Case Manager: Marty Lipkin, PLUM Committee Member

Overview of Site and Project

As pertaining to DIR-2019-4606—DRB-SPP-MSP for a 2-story, 3,406 SF single family residence with 2-car garage at 21075 Topochico Drive, Woodland Hills 91364, having held four (4) public meetings for the application for new construction of a structure in the Girard Tract and the outer core of the Mulholland Scenic Parkway Specific Plan, the Planning, Land Use and Mobility committee hereby finds that:

Updated rendering of rear (East) façade showing new balcony design and simplified window styling.

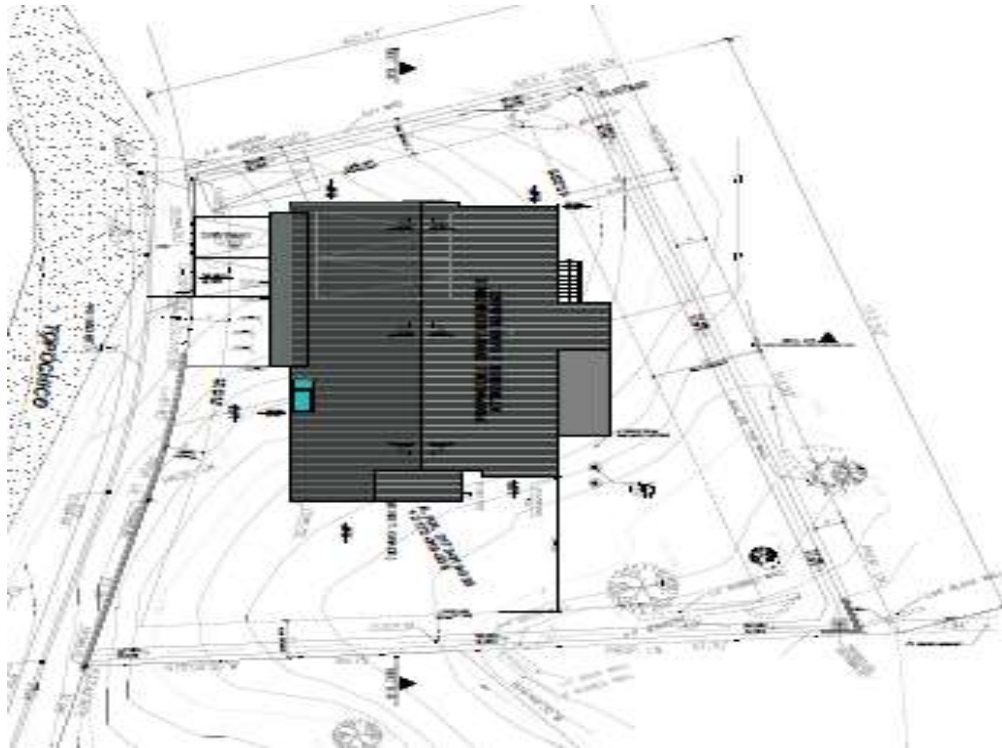
The redesigned/expanded structure features an additional 256 SF of space and significant exterior changes as well as architectural additions and refinements to both the front and rear elevations of the structure as well as to the south façade including additional windows, a modified front entry, and changes to the rear balcony and staircase.

The bulk of the newly expanded proposed structure will face to the east on the downslope of the property, with a large portion of the bottom floor's livable floor area built into the hillside. The originally proposed four (4) skylights in the center of the roof have been reduced to one (1) near a front entry atrium. One exterior iron staircase clad in a wood-like material extends from the upper floor of the rear of the structure to the down-sloping hillside, and the project indicates a single steel rail and glass patio/balcony at the rear of the home.

Site Plan for the proposed structure.

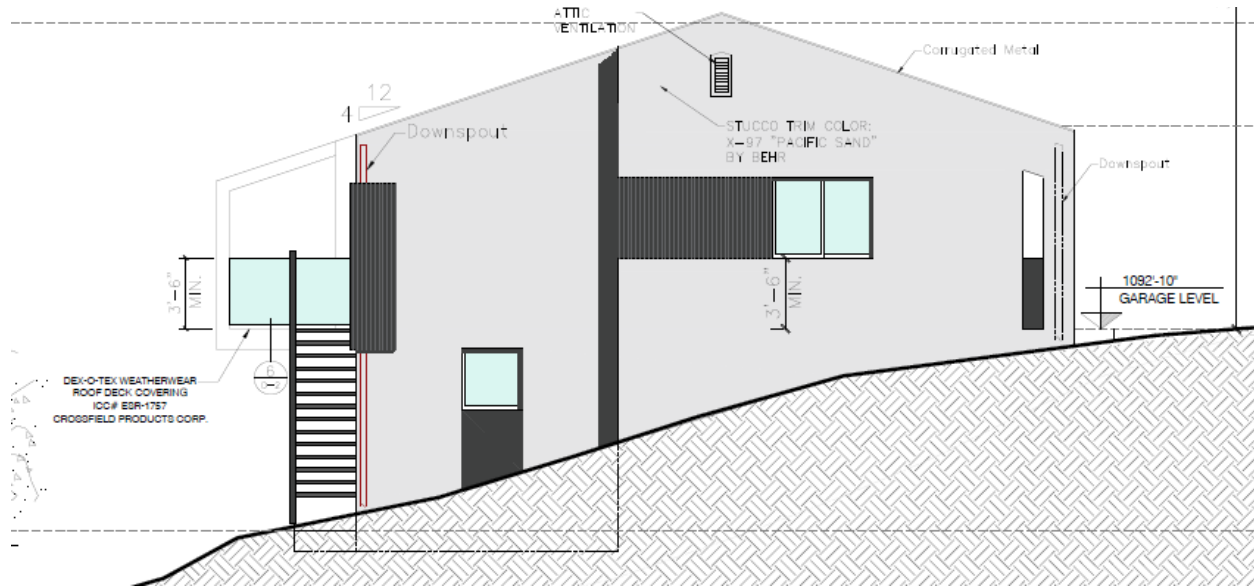
The building meets the baseline Hillside Ordinance minimum required 5' front yard setback along the substandard street, and the minimum 7' side yard setback required for buildings over 18' in height (1' added to side yard requirement of 5' minimum for each increment of 10' above height.) The substandard street will be widened to 20 feet wide along the width of the applicant's property, as required.

The building height measures 33' above finished grade at the pitched roof which complies with the Baseline Hillside Ordinance. The proposed Maximum Residential Floor Area (RFA), excluding the garage, is 2,987 sq. ft.

There is a retaining berm along the front street line that rises to just above street level in order to shore up hillside at the front of the home and prevent mud flows. There will be 28 caissons supporting the structure, sunk approximately 20' deep into the hillside. A “bridge” from the street to the garage entrance will have covered/shielded sides to prevent animal habitation and help ward off any erosion.
